County of Santa Clara

August 19, 2021

FILE NUMBER: PLN21-114
SUBJECT: Building Site Approval on Slope 30% or Greater and Grading Approval
SITE LOCATION: 0 Helen Way, Los Gatos, CA, 95033 (APN: 544-39-035)
DATE RECEIVED: July 20, 2021

Fig. 4.20-2
Parking Structure
—Sloping Lots

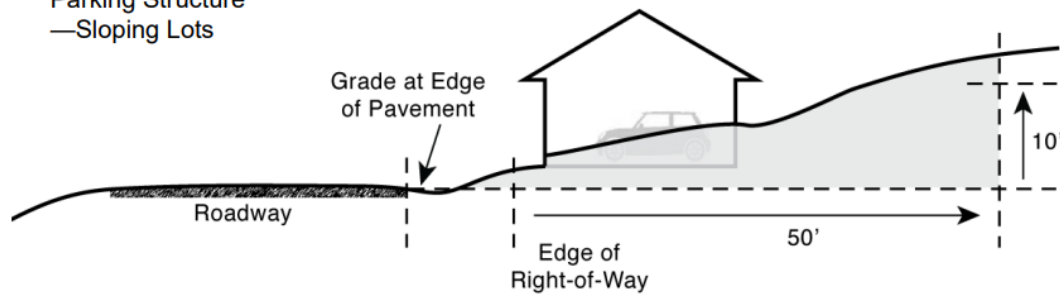
- a. A section drawing cutting through the Redwood Drive roadway and the proposed garage. The section cut shall extend a minimum of 50-feet beyond the edge of the right-of-way. Pursuant to Zoning Ordinance 4.20.020.(F).(1), “Where the grade elevation at a point 50 horizontal feet inward from the edge of right-of-way differs 10 vertical feet or more from the elevation at the adjacent edge of pavement, a garage, carport or other parking structure may be located within the required front or side yard of a lot.” (see Fig 4.20-2 inserted from Zoning Ordinance). **See section A-A**
